EPC STORMWATER REVIEW COMMENTS
IN ORANGE BOXES WITH BLACK TEXT

OVERLOT GRADING, POND SR4 & UTILITY CONSTRUCTION DOCUMENTS

FALCON MARKETPLACE

**AS-BUILT
10-17-2023**

**STORM SEWER
PLAN &
PROFILE**

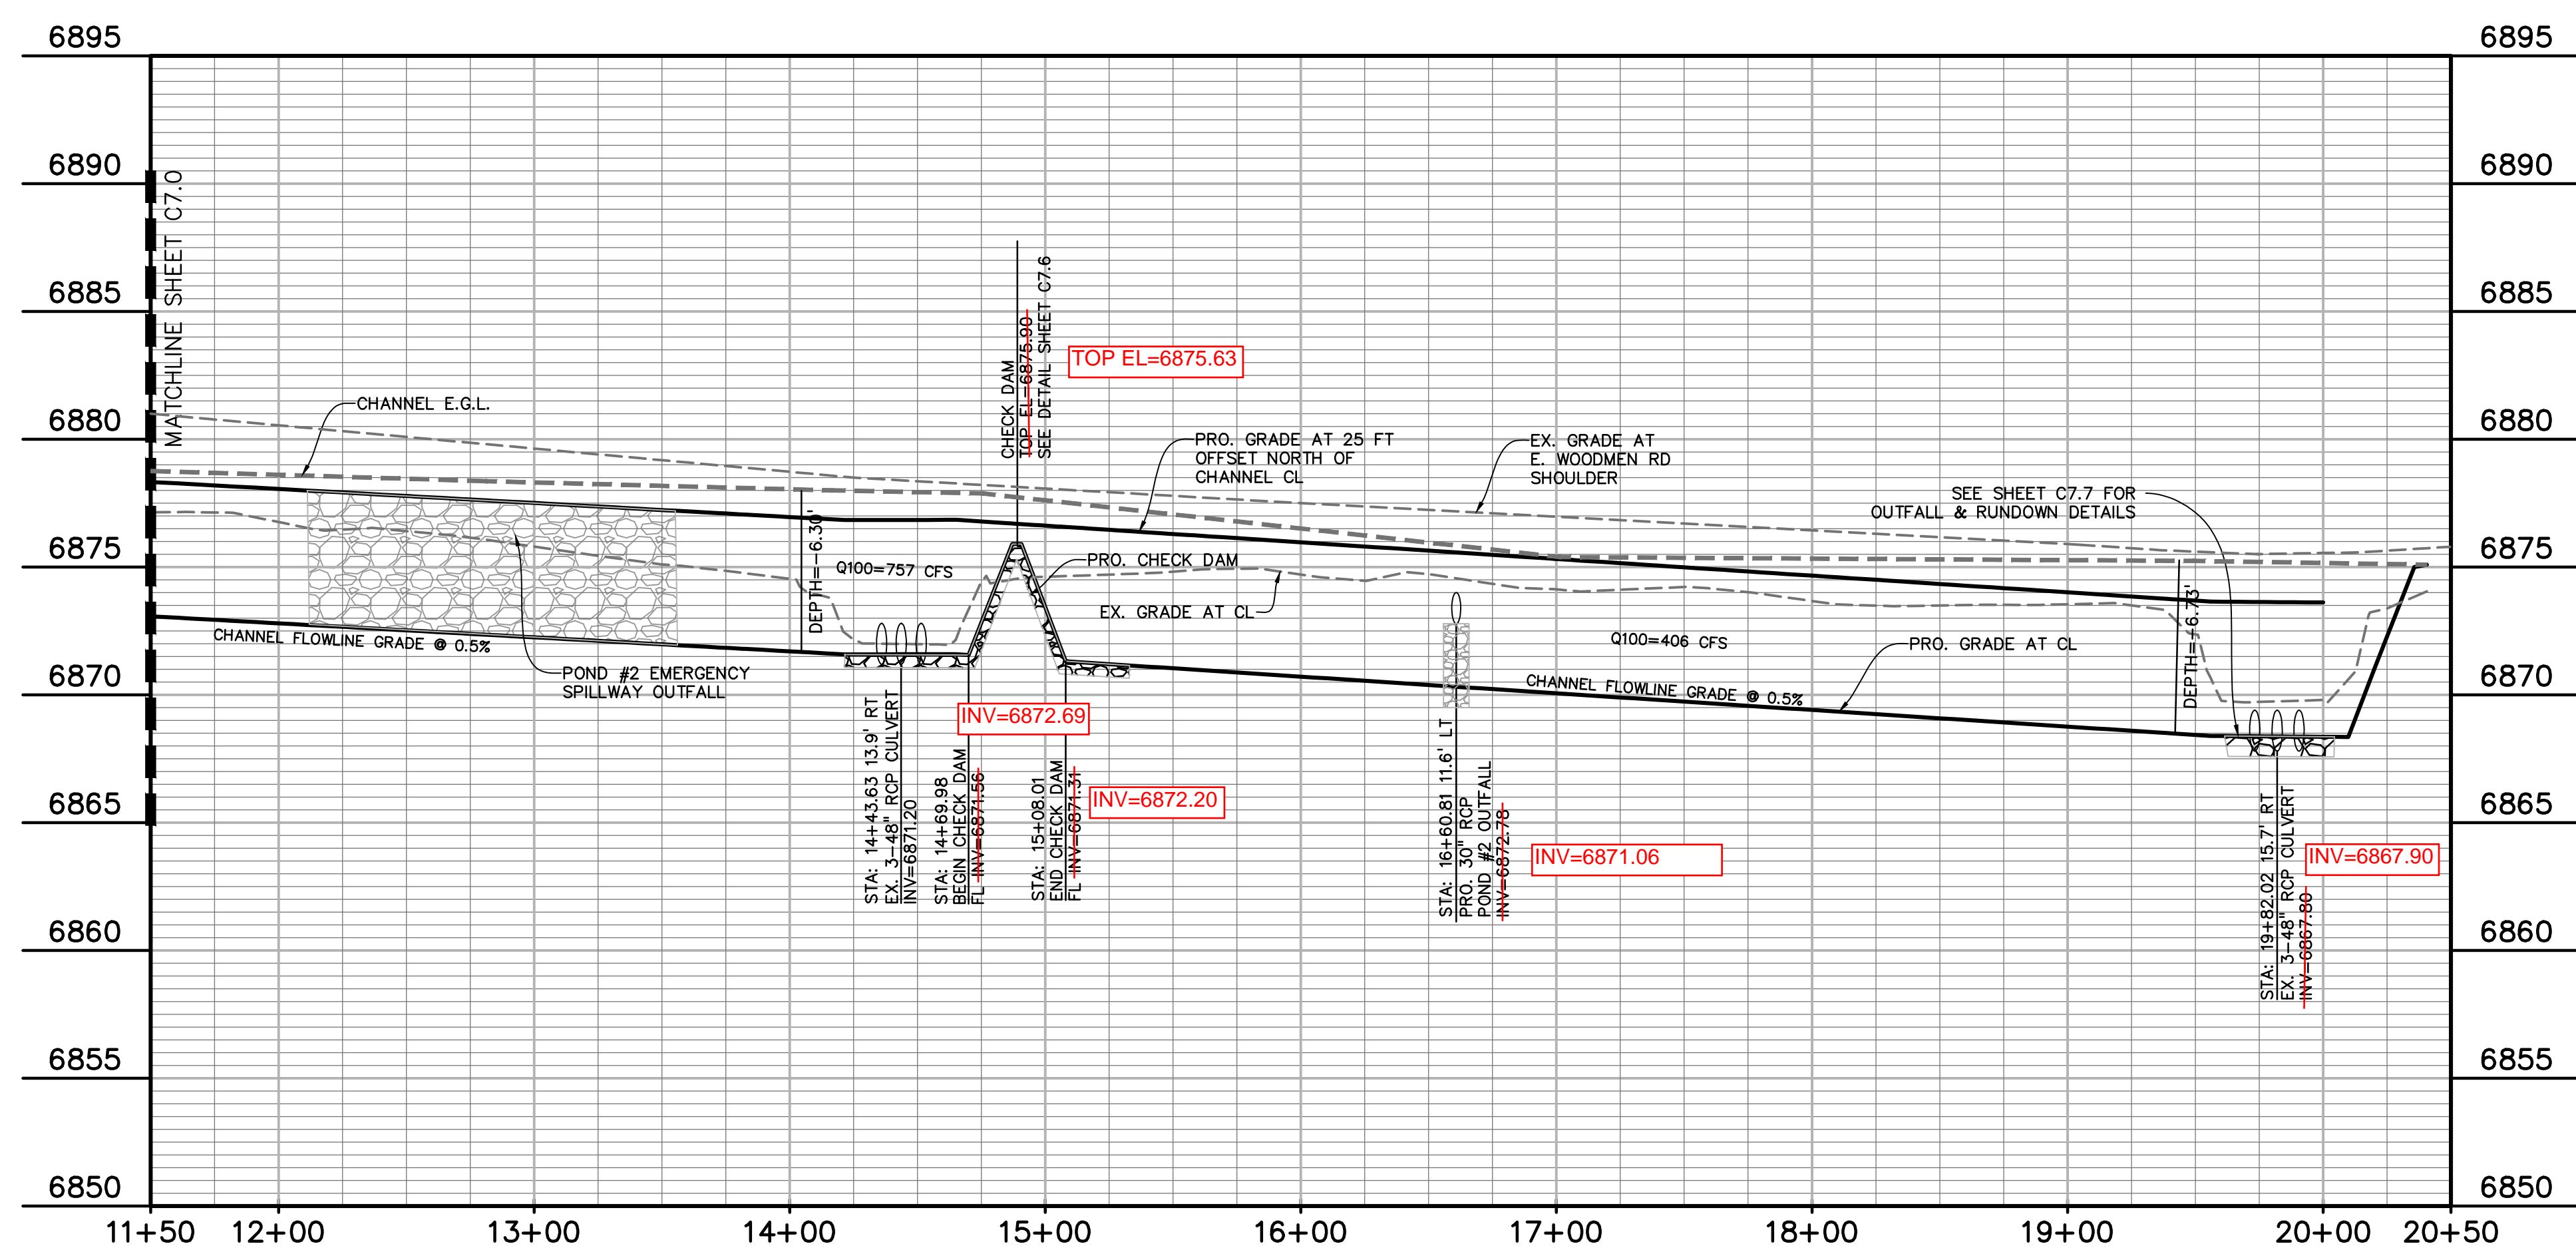
Show as-built topo data for the swale south of Pond 2 on this plan (in addition to the as-built elevations already shown in the profile below).

SUB-REGIONAL POND #1 (SR4)

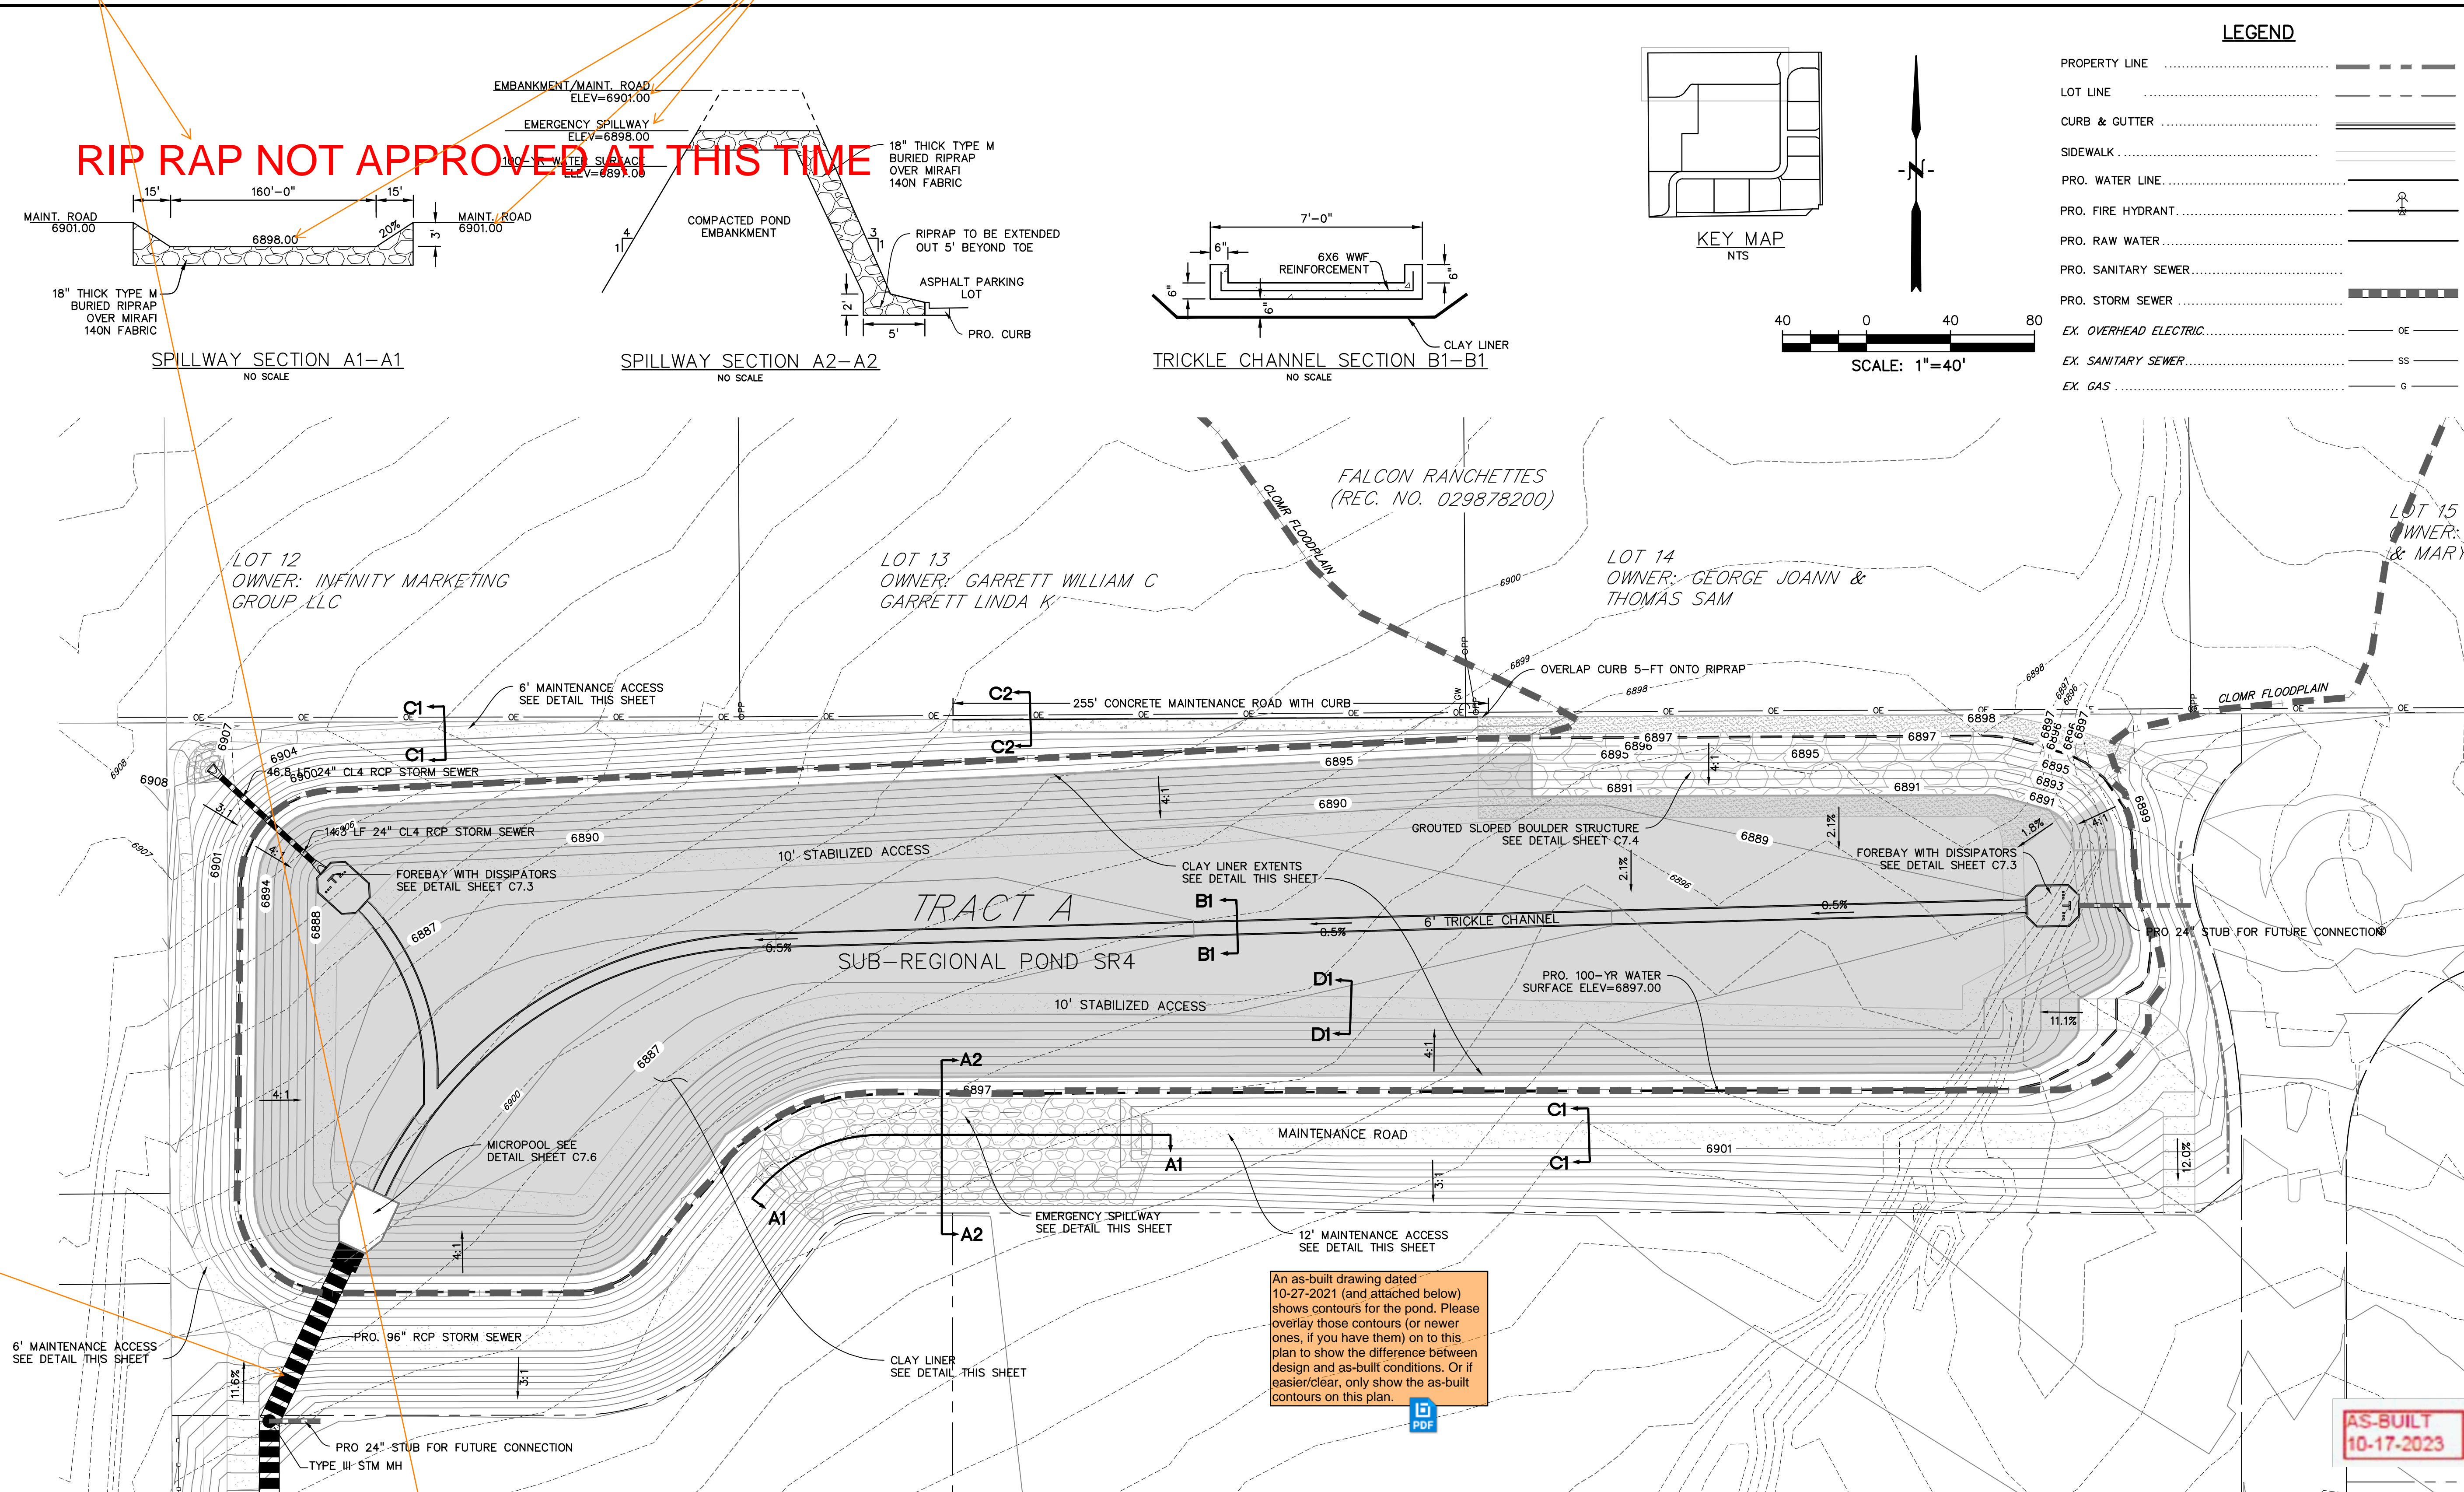
Were these elevations included in the as-built survey? If so, please update these elevations accordingly, if as-built conditions differ from these plans.

An as-built drawing dated 10-27-2021 (and attached below) shows contours for the pond. Please overlay those contours (or newer ones, if you have them) on to this plan to show the difference between design and as-built conditions. Or if easier/clear, only show the as-built contours on this plan.
